JAMES SUBDIVISION

Engineering Comments: FINAL PLAT COMMENTS (should be addressed prior to submitting the FINAL PLAT for review and/or signature by the City Engineer):

APPLICATION NUMBER 4 DATE September 7, 2017

DETAIL SITE PLAN

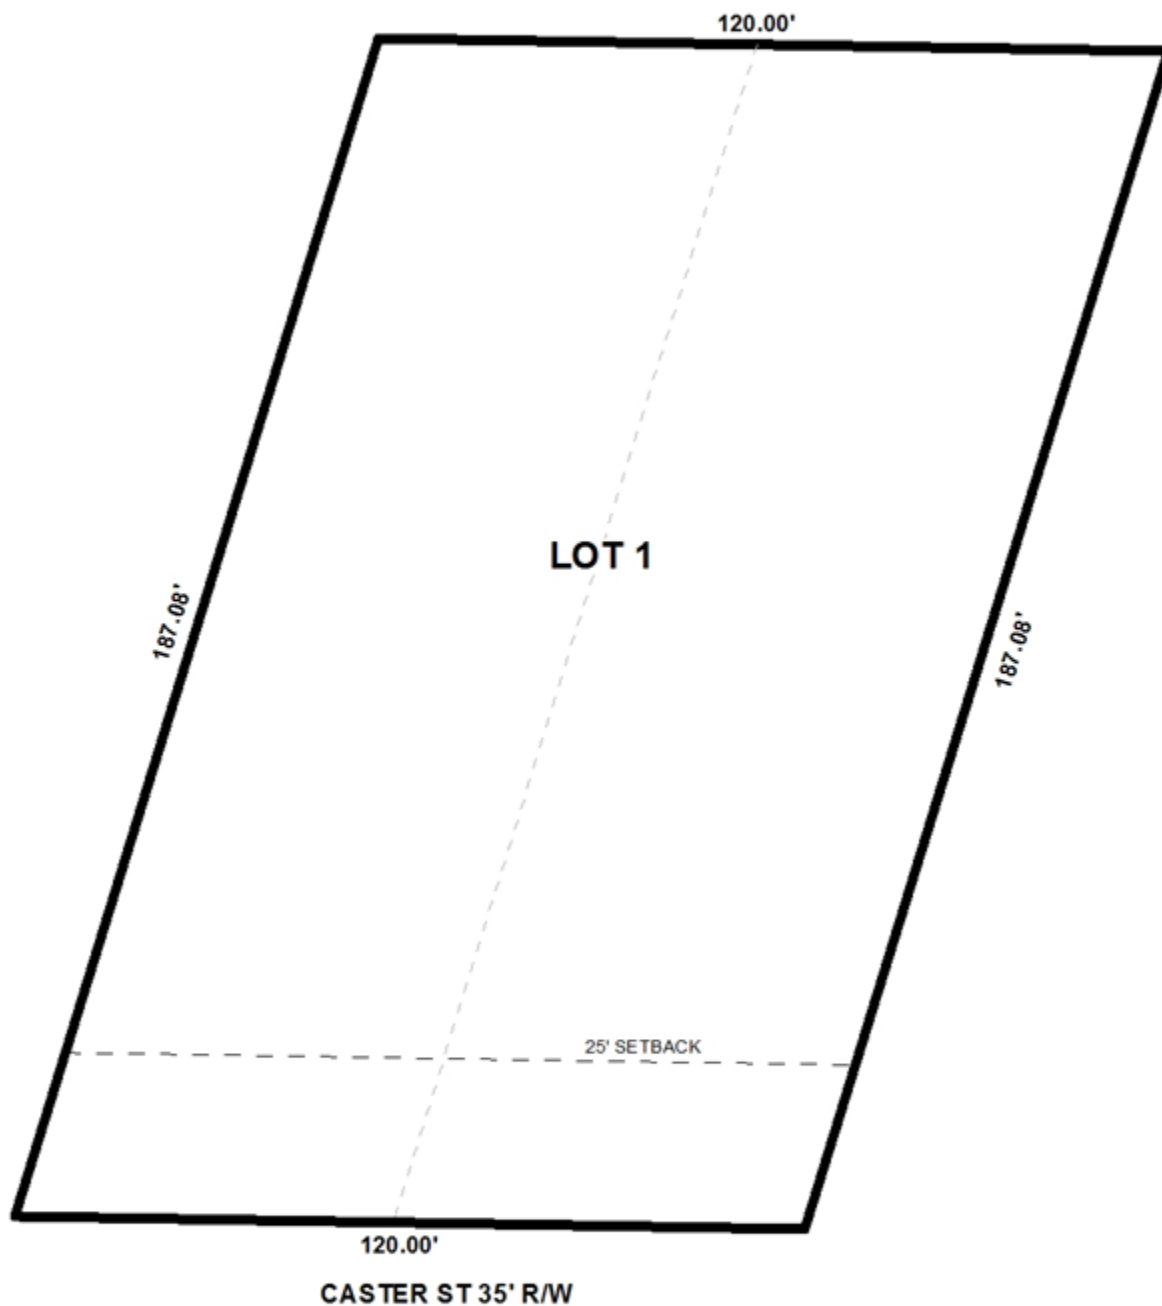
The site fronts Caster Street which is a minor street with a substandard 35' right-of-way and with substandard pavement width. As no curb and gutter is provided along the street, a 60' right-of-way width is required. Therefore, dedication to provided 30' from the centerline of Caster Street will be required. The plat should be revised to indicate such dedication with the 25' minimum building setback line revised to be measured from any required dedication.

As a means of access management, the lot should be limited to one curb, with the size, location and design to be approved by Traffic Engineering and conform to AASHTO standards, and a note should be placed on the Final Plat stating such.

The proposed lot meets the minimum size requirement of the Subdivision Regulations. The plat should be revised to label the lot with its size in both square feet and acres after any required dedication, or a table should be furnished on the Final Plat providing the same information.

- 1) dedication to provide 30' from the centerline of Caster Street;
- 2) revision of the plat to illustrate the 25' minimum building setback line as measured from any required frontage dedication;

- 3) placement of a note on the Final Plat stating that the lot is limited to one curb cut to Caster Street, with the size, location and design to be approved by Traffic Engineering and conform to AASHTO standards;

- 4) revision of the plat to label the lot with its size in both square feet and acres, after any required frontage dedication, or the furnishing of a table on the Final Plat providing the same information;
